## **Additional Questions:**

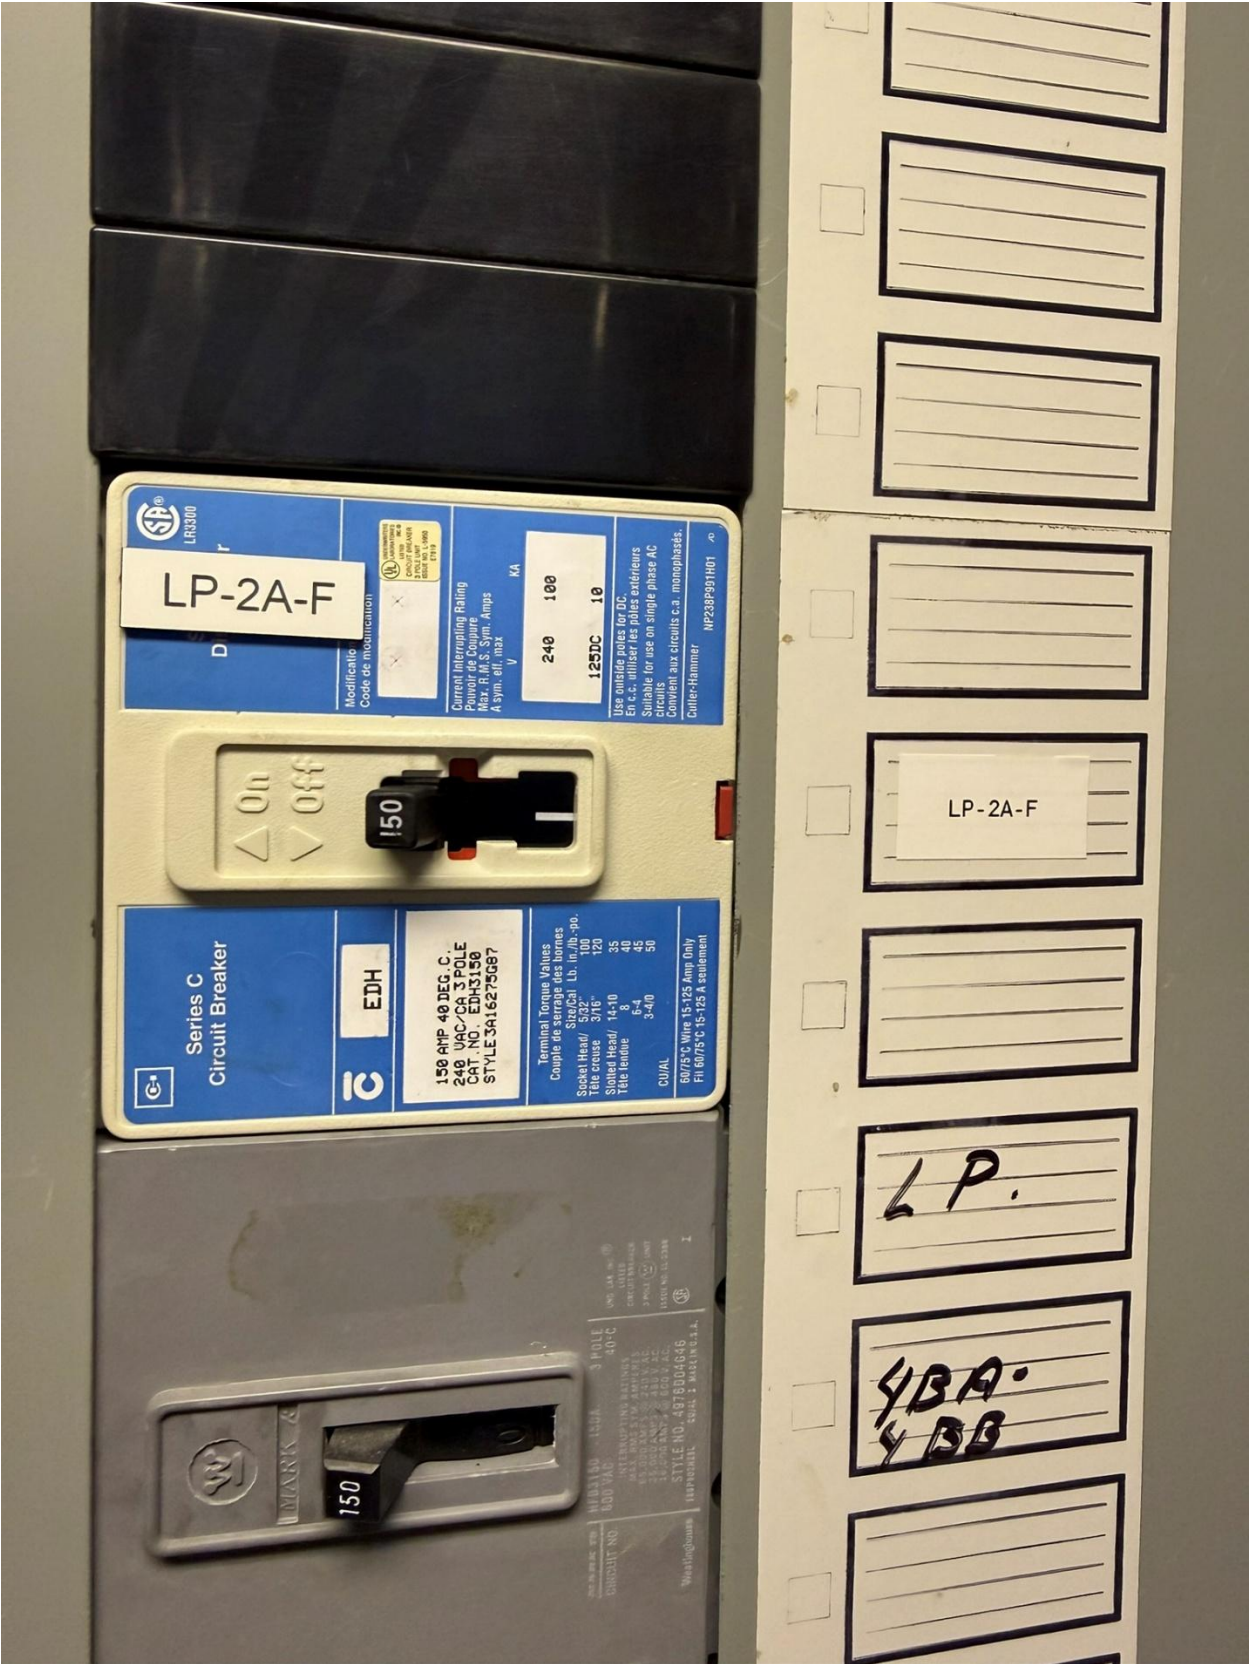
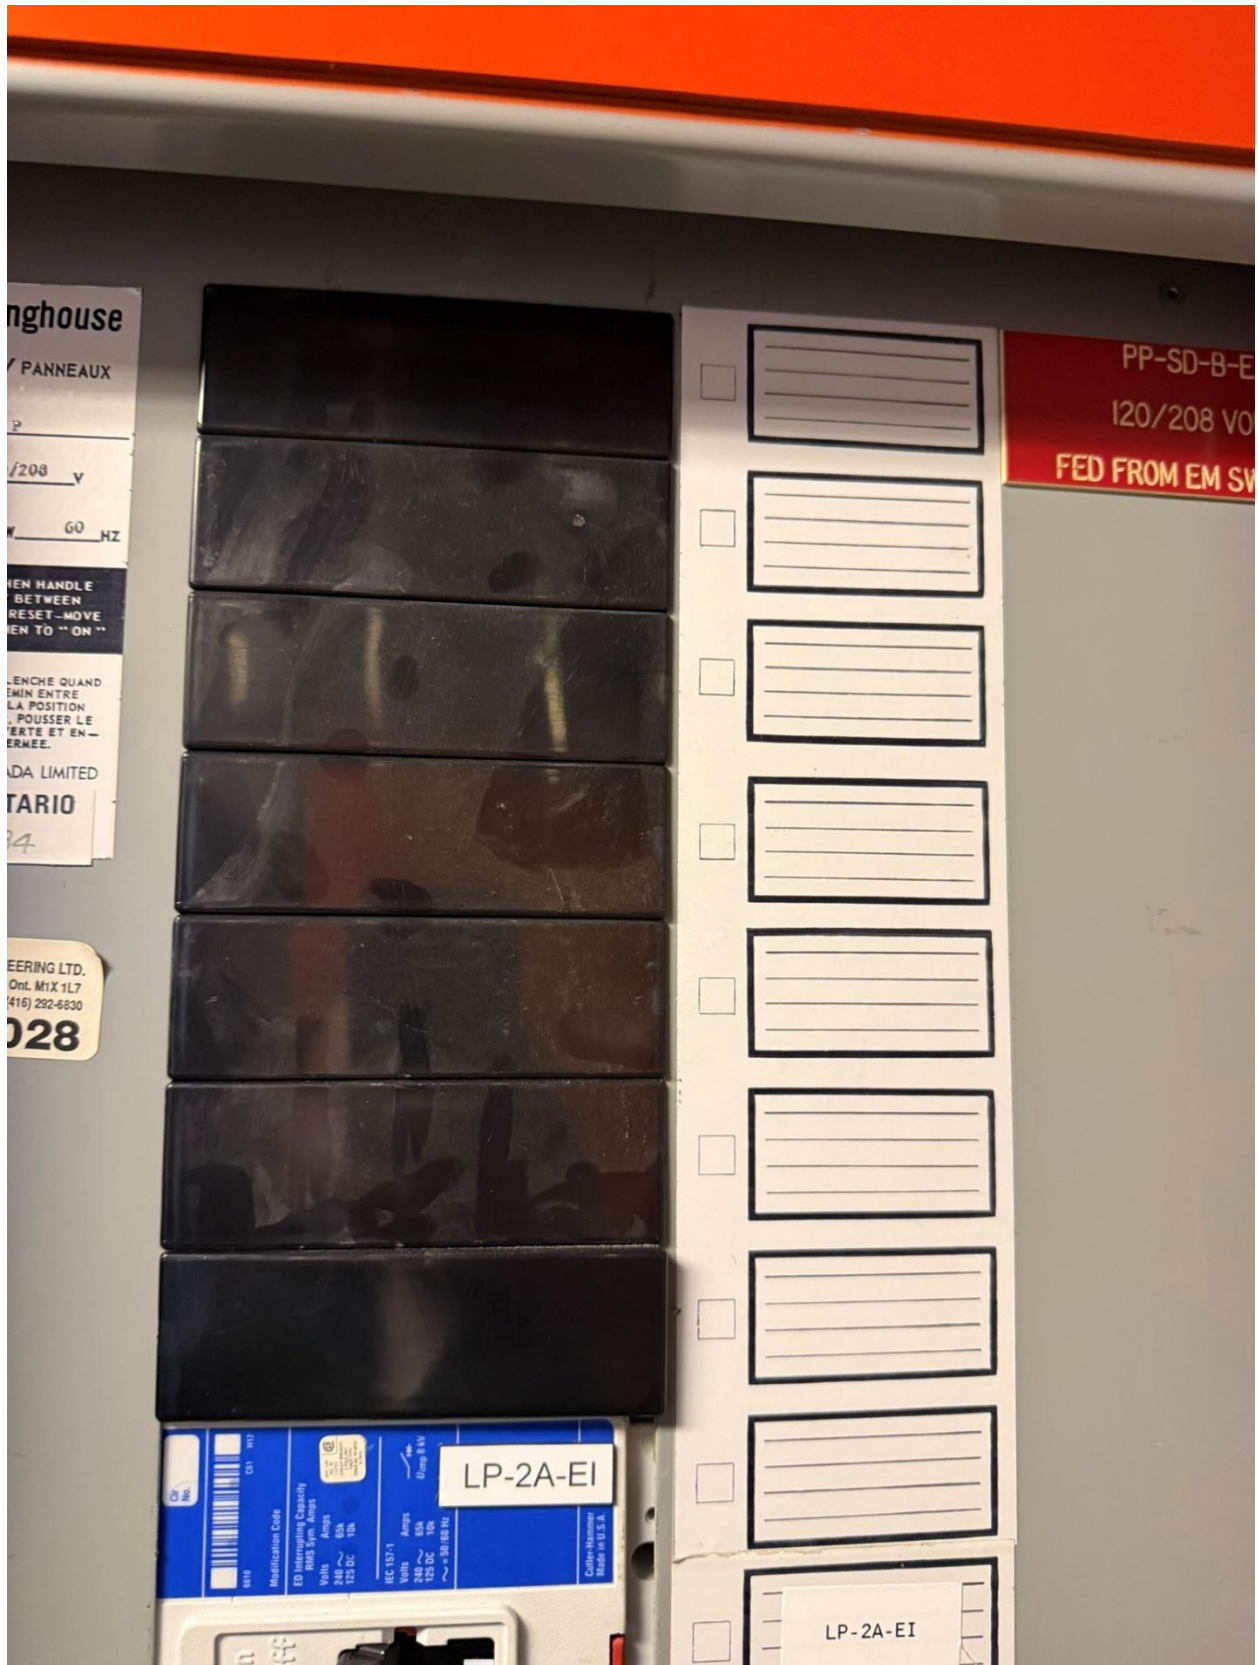
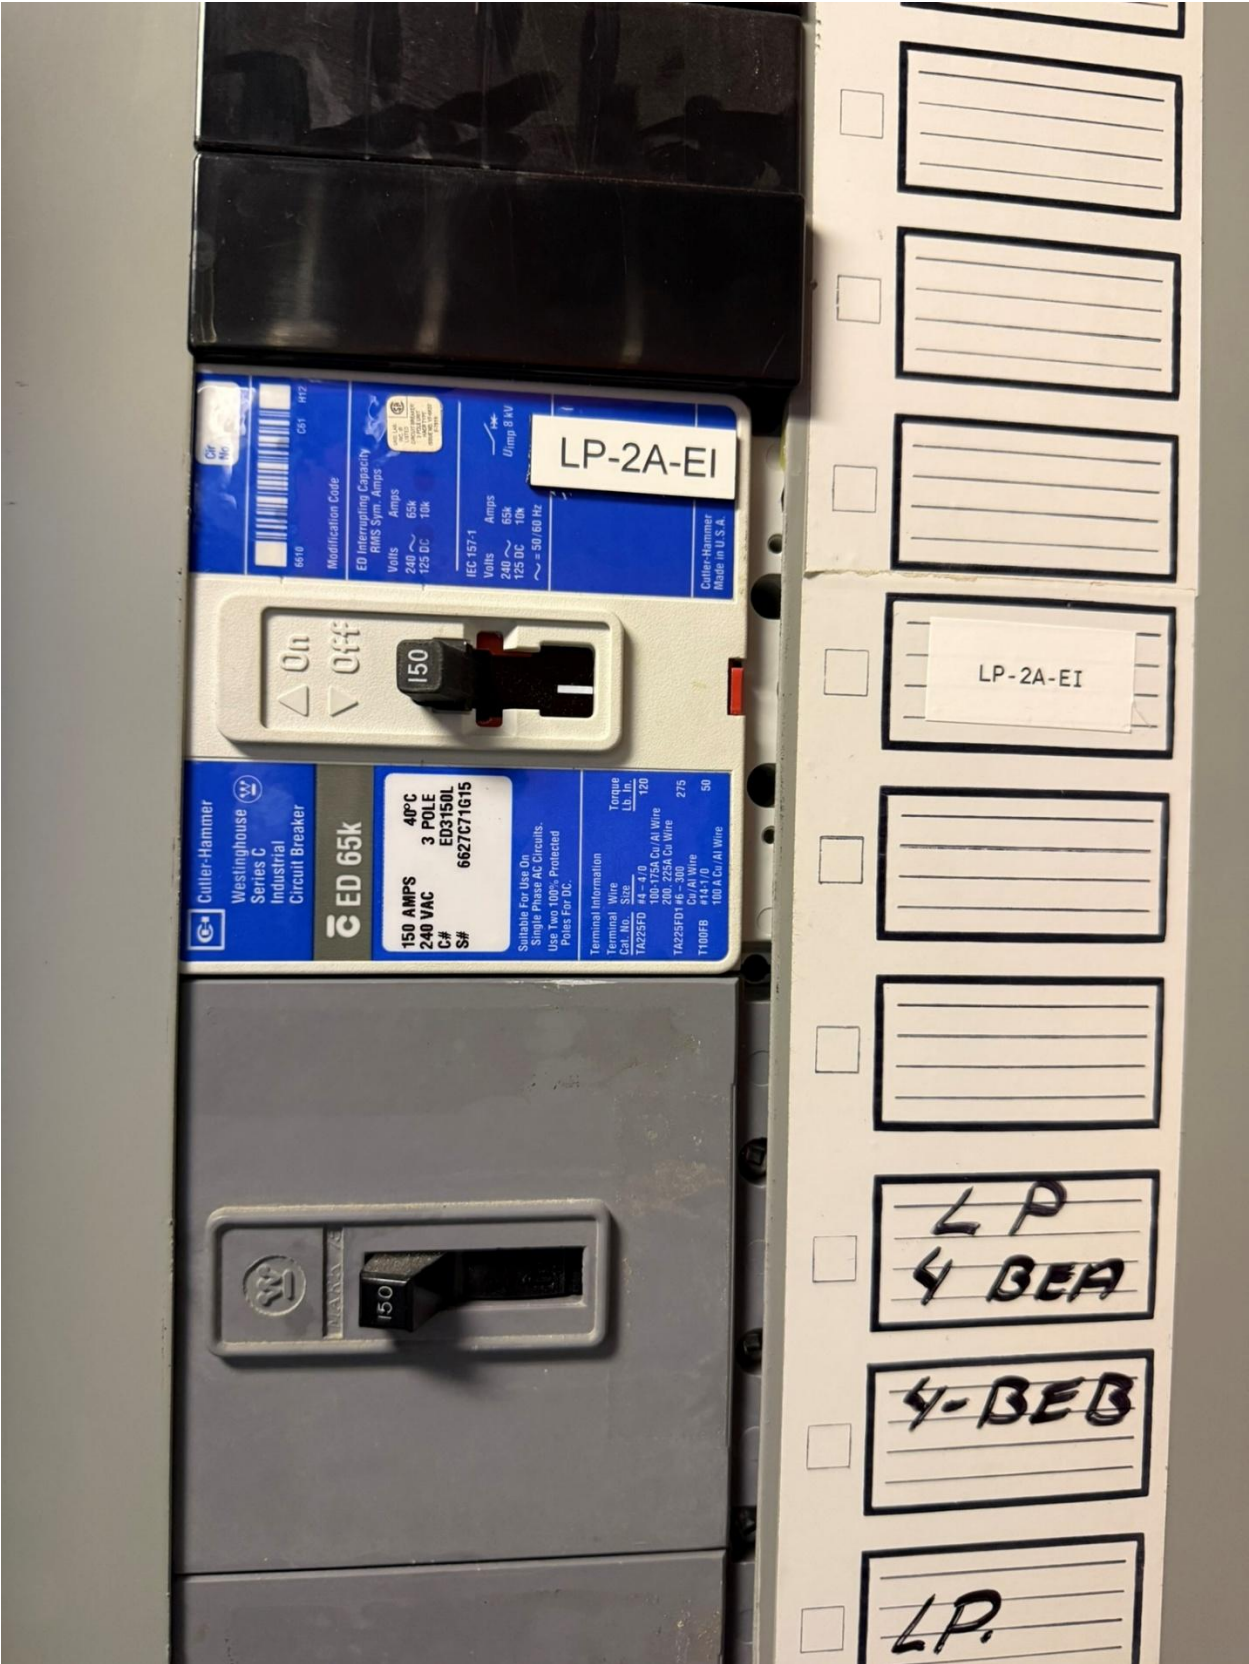
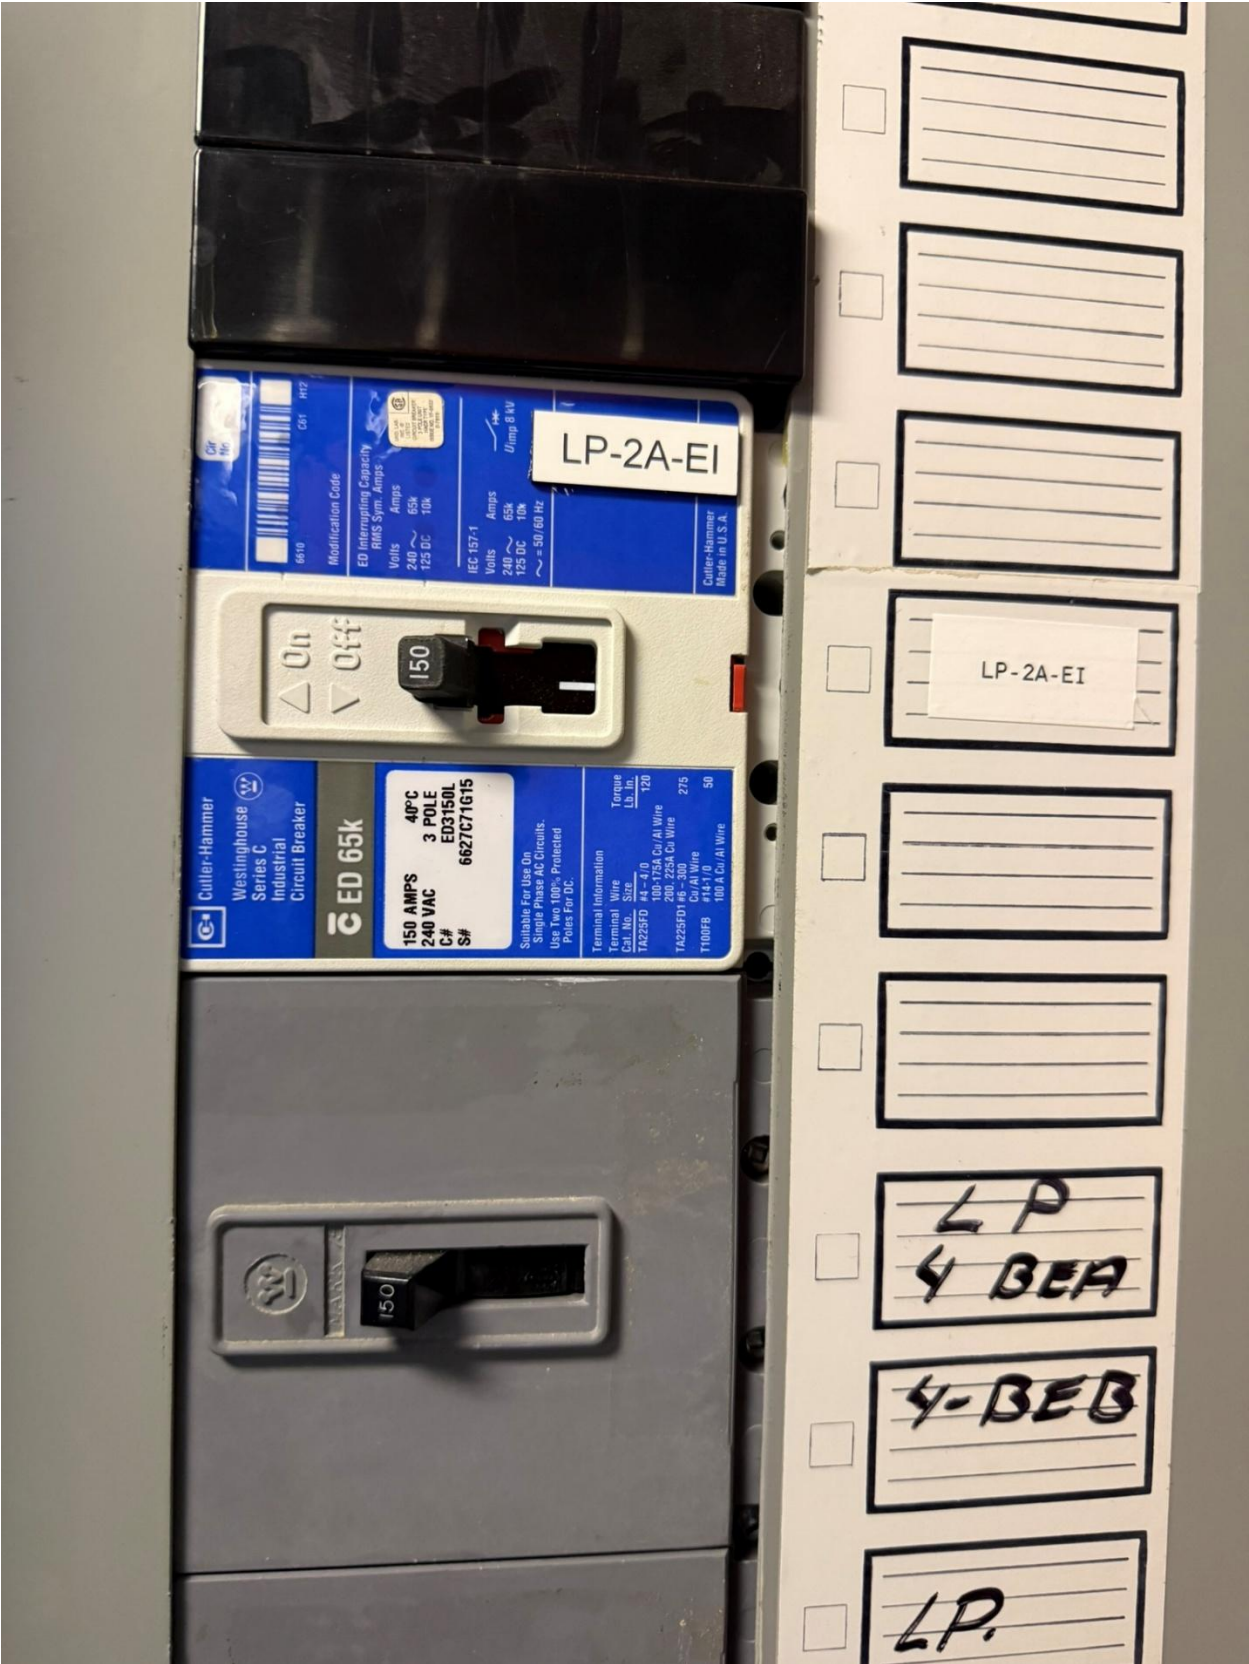
**Question 5: As per electrical addendum E-01, we have to provide 4 new 150A breakers in existing panels PP-SD-B-EAA & PP-SD-B-AA. Here, we need photos of these panels with breakers details and panel details such as manufacturer, panel amperage, voltage and KA Rating.**

Photos below
